DOCKET NO. 40-9027
LICENSE NO. SMC-1562
LICENSEE: CABOT PERFORMANCE MATERIALS, REVERE, PA
SUBJECT: SAFETY EVALUATION REPORT, SITE
DECOMMISSIONING PLAN, AND RADIOLOGICAL
ASSESSMENT, DATED MAY 24, 2001

Figure 1. Generalized conceptual model used in the Cabot-Revere assessment.

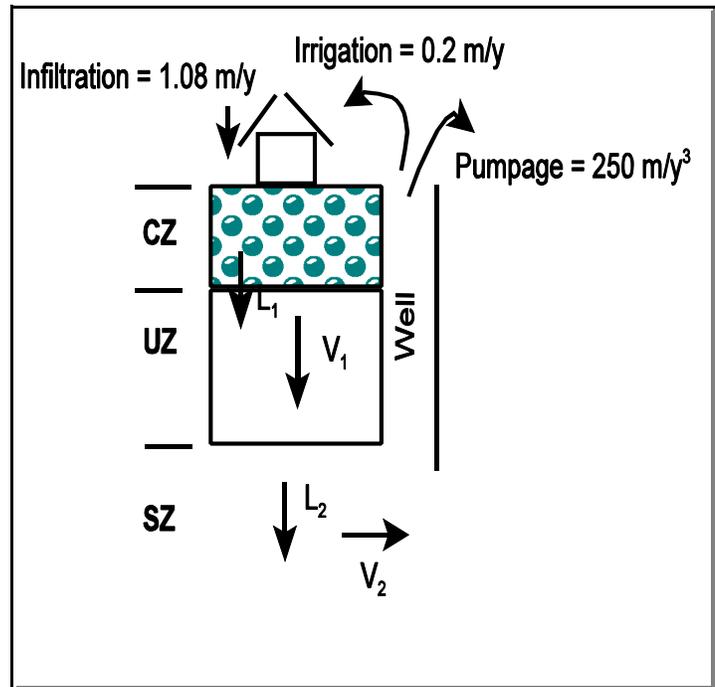
Figure 1 shows a schematic of the general conceptual model used in the Cabot-Revere RA, based on the staff's interpretation of the information presented in the report.

It should be noted that a default irrigation rate of 0.2 m/yr (0.7 ft/yr) was used in the analysis, although the licensee only assumed irrigation as part of its residential gardener scenario.

Based on regional information, the unsaturated zone is believed to be roughly 20 m (66 ft) thick; however, for the assessment, nominal credit is taken for the possible hold-up of contaminants migrating through the unsaturated zone. This is reflected by the small unsaturated zone thickness [0.01 m (0.03 ft)] assumed for the analysis. Staff believes that this adds conservatism to the calculated doses for the water-dependent pathways.
